HOPE BAY MINING LIMITED

2008 Annual Geotechnical Inspection, Boston Advanced Exploration Project, Hope Bay, Nunavut

Project No. 1CM008.006

March 2009

Photo 10: Surficial slip surfaces on the west face of the primary tank farm berm.

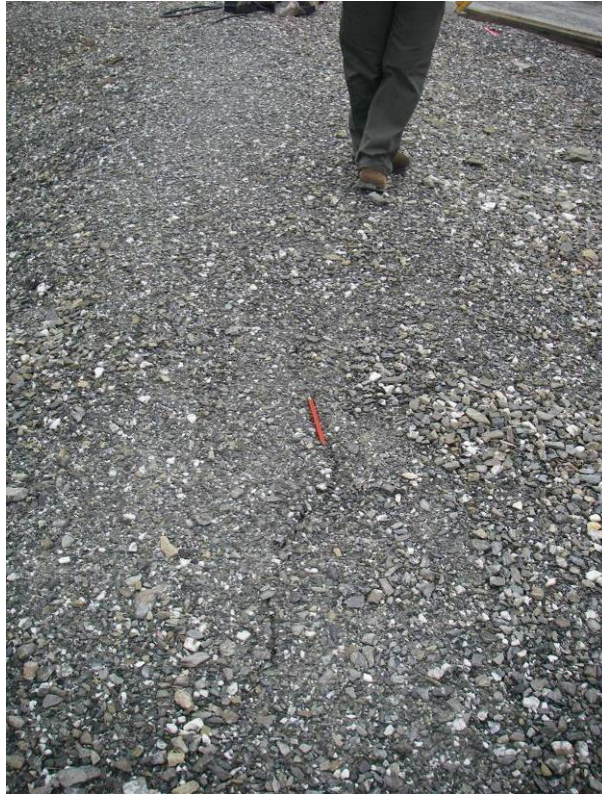
Visual inspection of the secondary containment facility showed several signs of surficial slip surfaces on the containment side slopes, as well as small tension cracks along the berm crest. These were not observed during the 2007 inspection and should be monitored closely. These slip surfaces could be an early indication of settlement, or may simply be due to the oversteepened nature of the gravel berm. The liner is not exposed anywhere, and the containment berms for both the main containment facility and the fuel transfer areas are intact. There were no visible signs of fuel spills outside of the respective containment areas. HBML has rigorous protocols in place for fuel transfer, and provided those are followed, the facility design appears adequate to ensure environmental protection.

1. The appearance of surficial slip surfaces and tension cracks on the containment berms should be closely monitored. Remedial measures should be put in place if there are any signs of these progressing. Should excessive deformation of these berms occur (the probability of which is likely low), the tank integrity is not at risk. It is simply the secondary containment that will no longer be in place.
2. The tank settlement monitoring program that has been put in place is good. Quarterly monitoring (or as close to this schedule as the camp operating window allows) of tank
